ROAD SAFETY AUDIT – STAGE 2

S278 AGREEMENT

114 – 116 HIGH STREET

BARWELL

Proposed Site Entrance

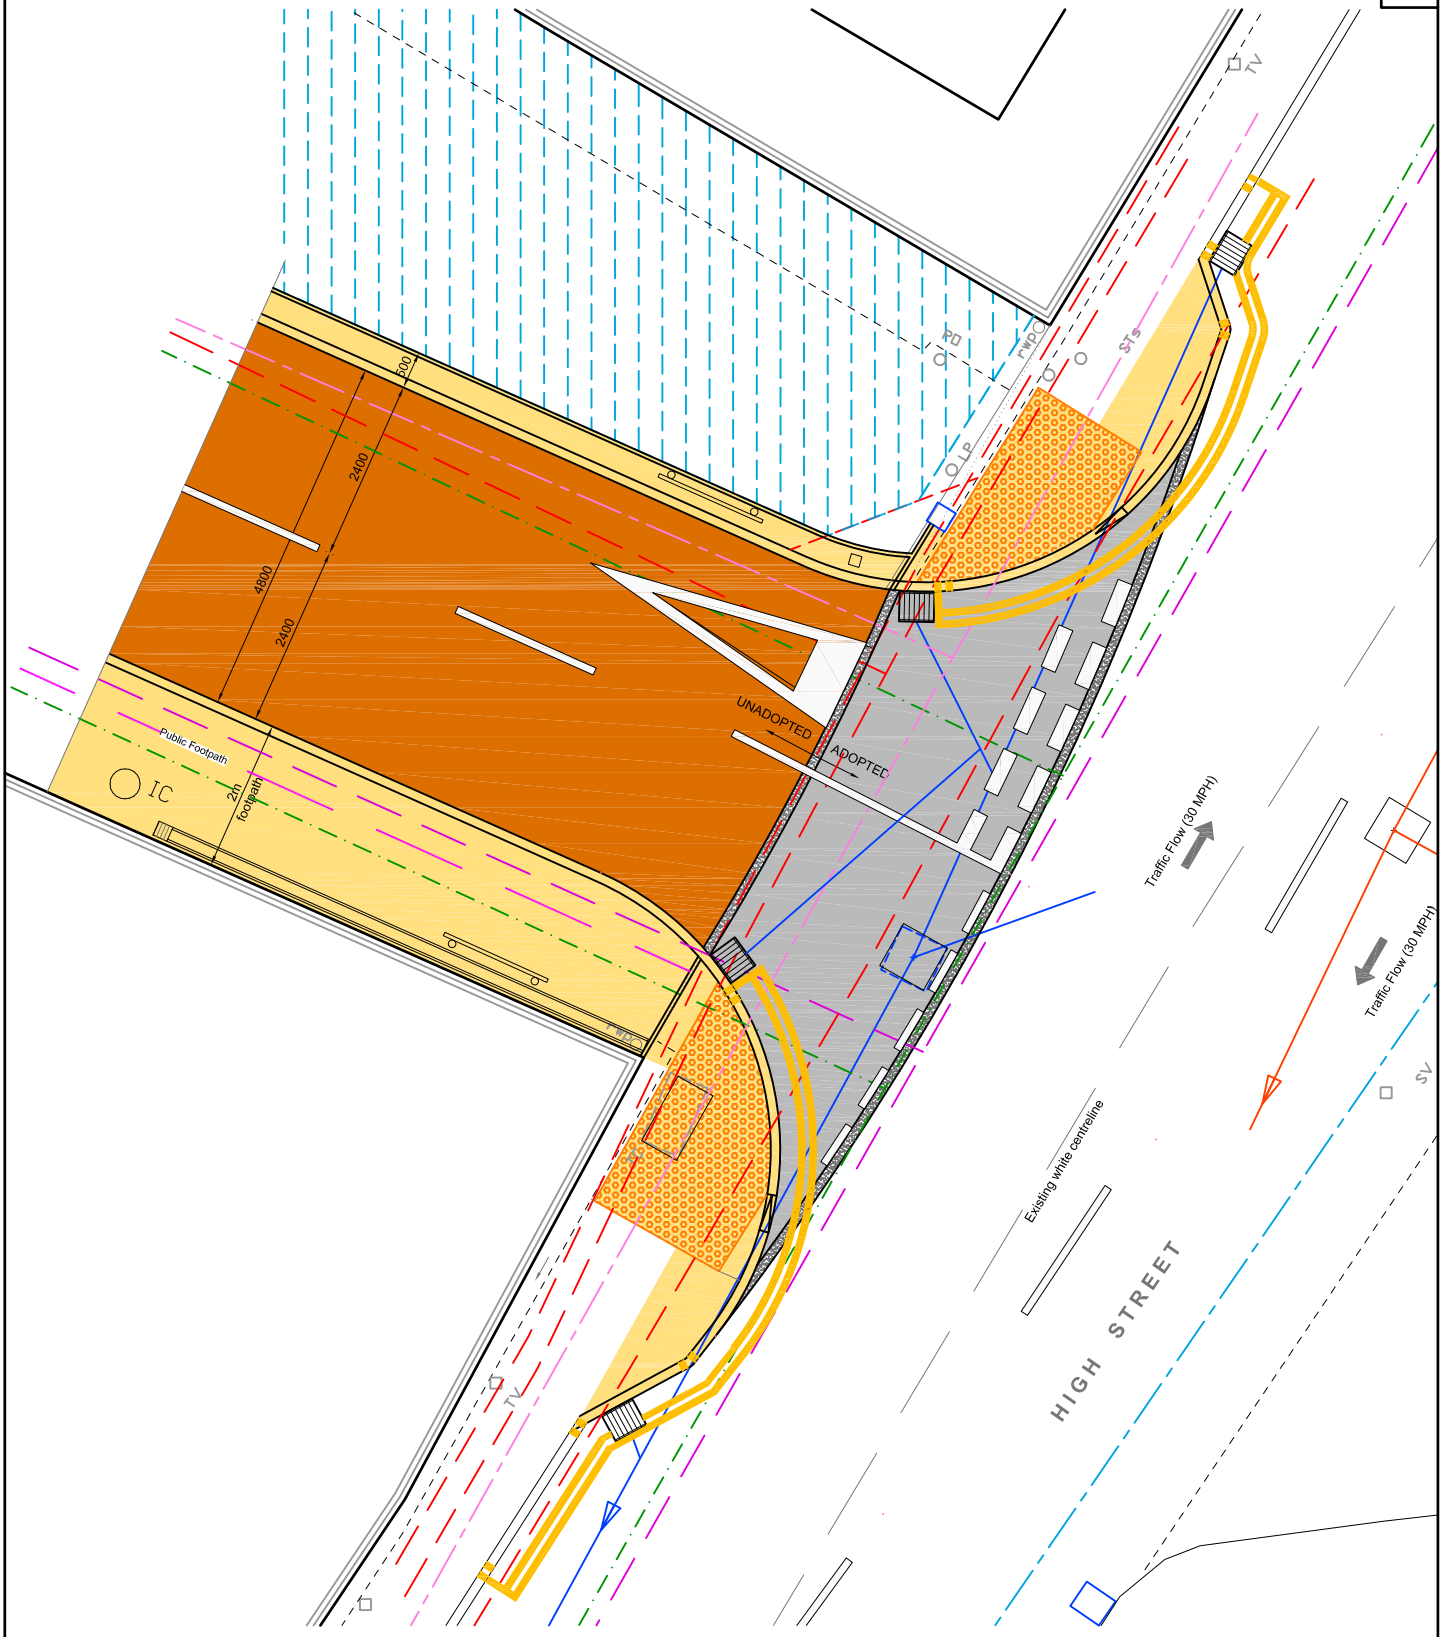
3.4	**Road Markings**		
	Do the carriageway markings clearly define routes and priorities?	No new routes or priorities proposed. Realignment of the road centerline is minor. Proposed carriageway markings for the existing minor road accessing the main road added to reinforce existing 'give way' priority. No markings currently exist.	None
	Are the dimensions of the markings appropriate for the speed limit of the road?	Yes	None
	Have old road markings and road studs been adequately removed.	Old centerline markings to be burned off and reset as shown on the Drawings. No existing studs.	None
